Supporting explanations for P802.3dj draft D1.0 comments

John Johnson, Broadcom

Comments against P802.3dj draft D1.0

Table 183-6—800GBASE-FR4 and 800GBASE-LR4 transmit characteristics

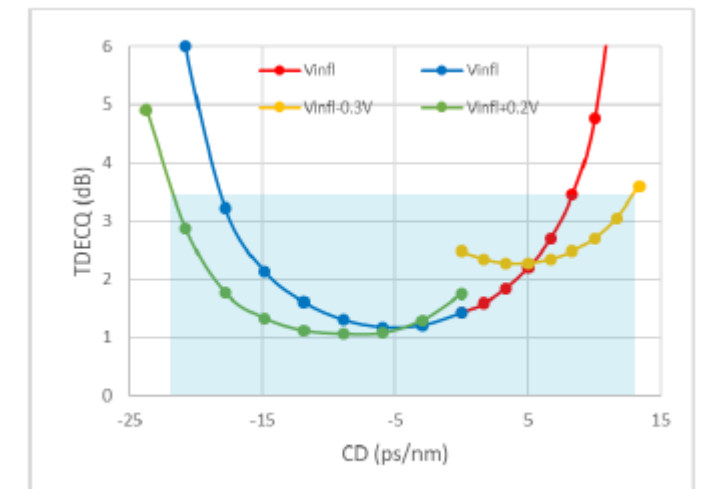
- A TX must be compliant over the full range of fiber length (chromatic dispersion), so the use of TDECQ alone is insufficient to determine Outer Optical Modulation Amplitude ($\text{OMA}_{\text{outer}}$), each lane (min) in Table 183-6 (800GBASE-FR4/LR4).

- It's possible to bias an EAM such that $\text{TDECQ} < \text{TECQ}$ when the EAM has non-zero chirp and the fiber has significant dispersion ([Johnson 3df 01a 221011](#))

- This TX spec methodology is already adopted in clauses 180, 181 and 182.
- **Propose to replace TDECQ with $\max(\text{TECQ}, \text{TDECQ})$ in Table 183-6.**

- Note that " $-0.1 + \max(\text{TECQ}, \text{TDECQ})$ " is already in Equation 183-1 referenced in Table 183-6.
 - For consistency with clauses 180-182, replace "Equation 183-1" with " $-0.1 + \max(\text{TECQ}, \text{TDECQ})$ " in Table 183-6, and delete Equation 183-1 on page 435, line 20. (not sure why it's there)
